PURPOSE: Discusses the findings of the final layout for the SIGA.

FILE: doc_31 SIGA (DESIGN) SIGA LOGIC DESCRIPTION

This document, in addition to the attached documents and drawings, will provide a guide for understanding the SIGA design by "walking through" the hierarchies of the schematics.

I have reviewed the tape of the latest clocking structure for the L1A3496. The preliminary results show that there is a potential hold-time problem relating to the T_CLK/Z net. Please review the attached document regarding this problem and contact me to discuss your thoughts on it.

FIGURE 1

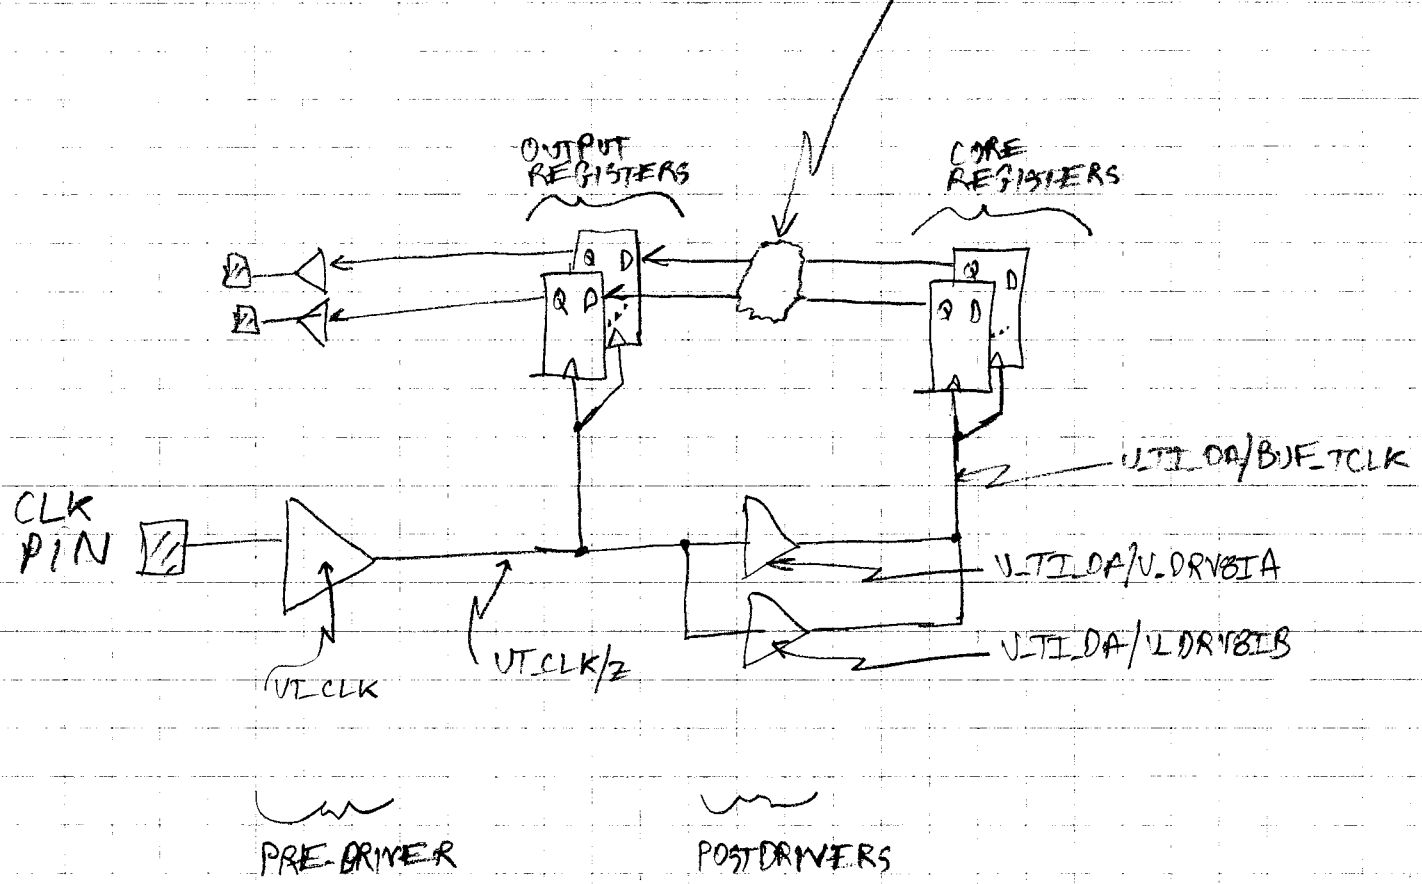
Figure #1 shows the schematic of the relevant portion to the circuit. Note that there are about 117 "output registers" and about 208 "core registers".

FIGURE 2

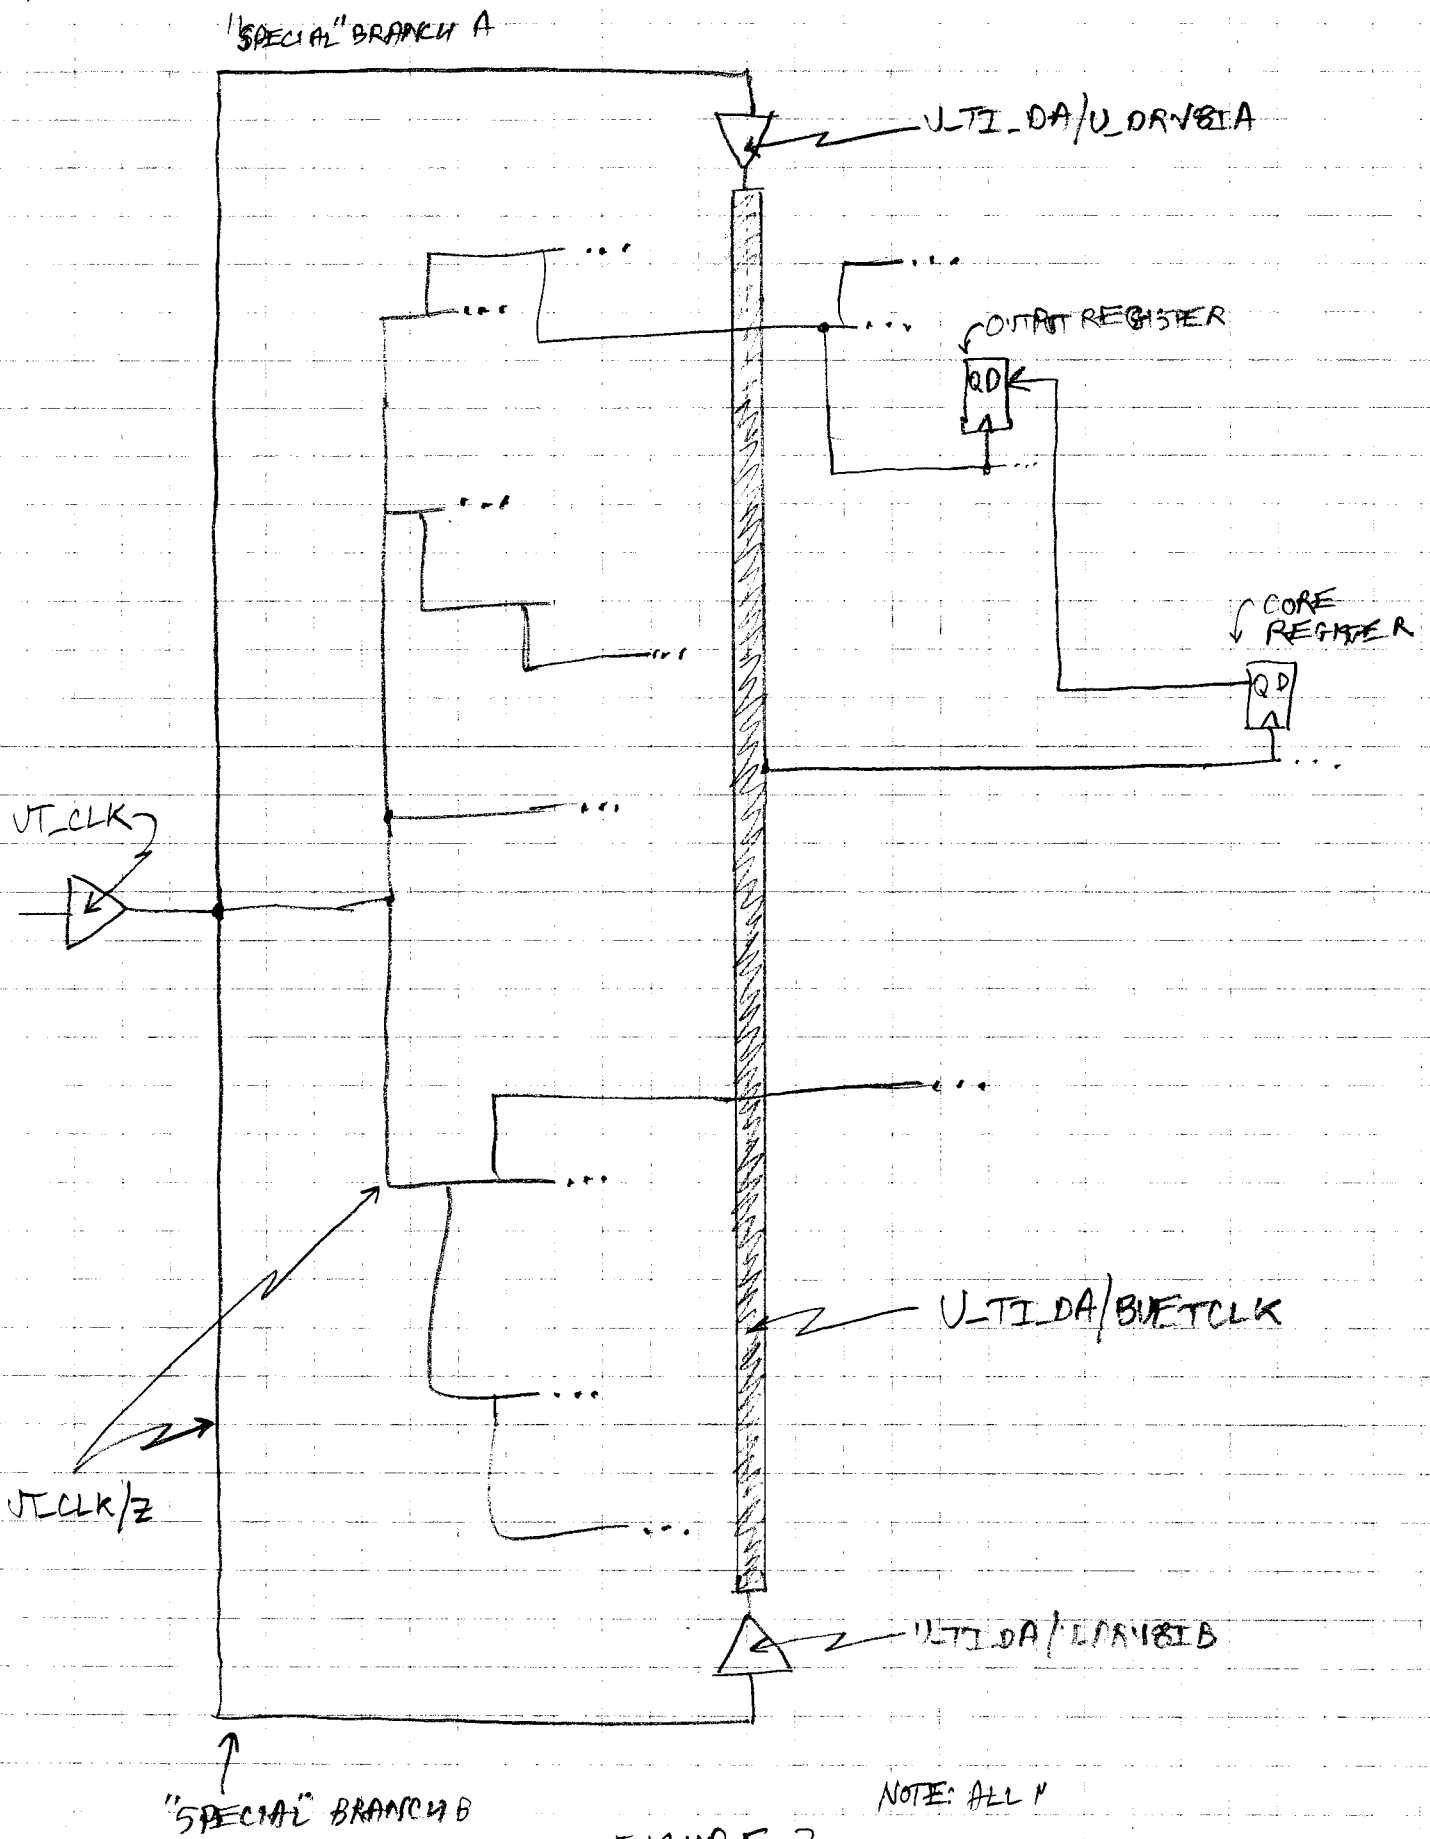
Figure #2 shows the current layout structure of the elements in Figure #1. The "special" branches A and B (of the UT_CLK/Z net) are used to provide a balanced path from the predriver (UT_CLK) to the postdrivers (U_TI_DA/U_DRV81A, U_TI_DA/U_DRV81B).

FIGURE 3

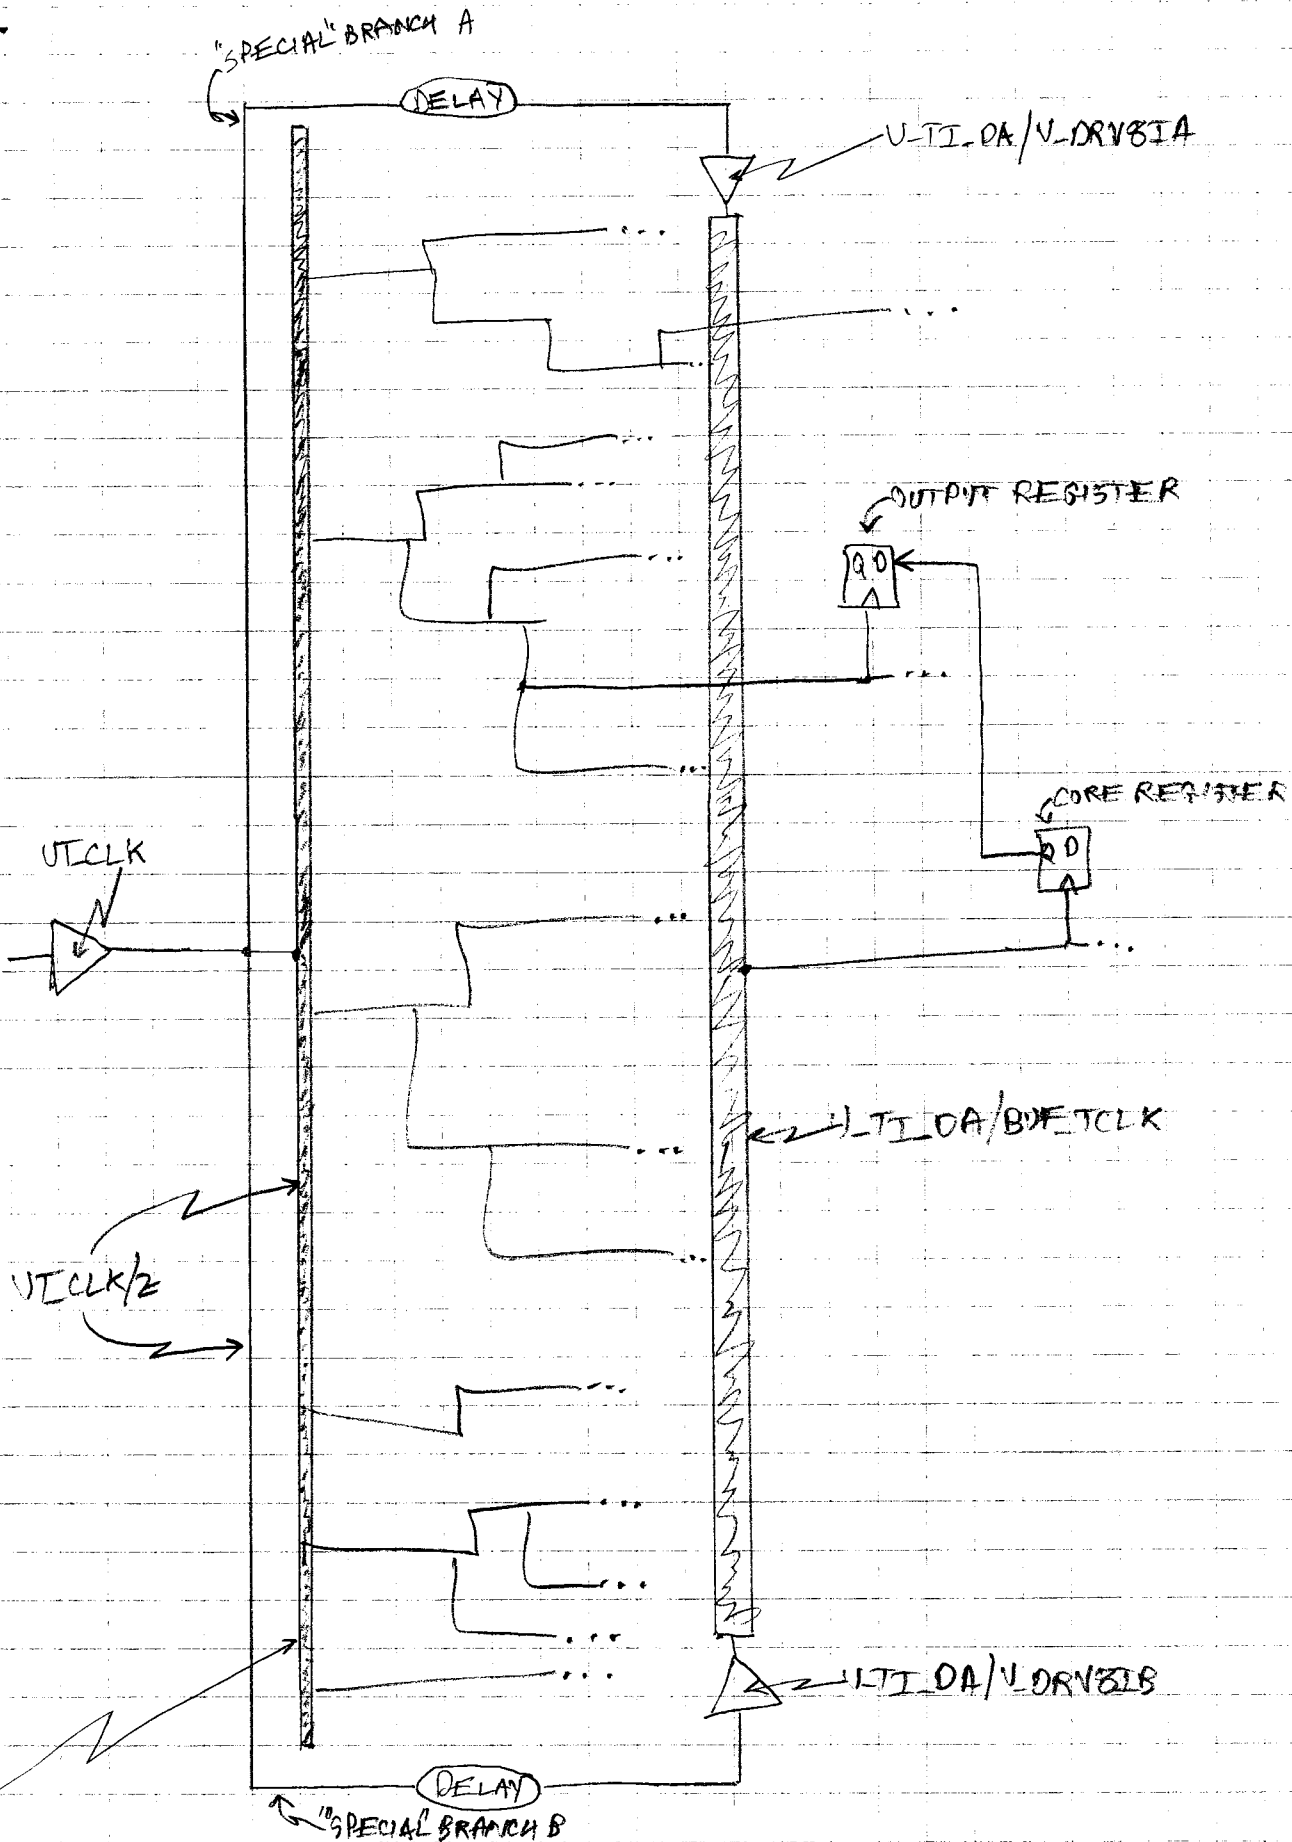
Referring to Figure #3, I think the problem should be attacked from two angles: 1) speed-up the UT_CLK/Z net, and 2) skew the U_TI_DA/U_DRV8IA net even more, relative to the UT_CLK/Z net. This is accomplished as follows:

SAME WIDTH AS THE NET "TENA_HOLD"

Speed-up the UT_CLK net: Add a "pseudo" clock net trunk from which tributaries to the output logic are attached. This should be done exactly as it was done for the T_ENA_HOLD net (not shown), making a trunk of the same width.

Skew the U_TI_DA/U_DRV8IA clock net: Leave the two special branches (A and B) basically intact but add some balanced serial delay (about 1.2 ns @WCCOM) by increasing their length or adding loads (whatever you think is the best way).
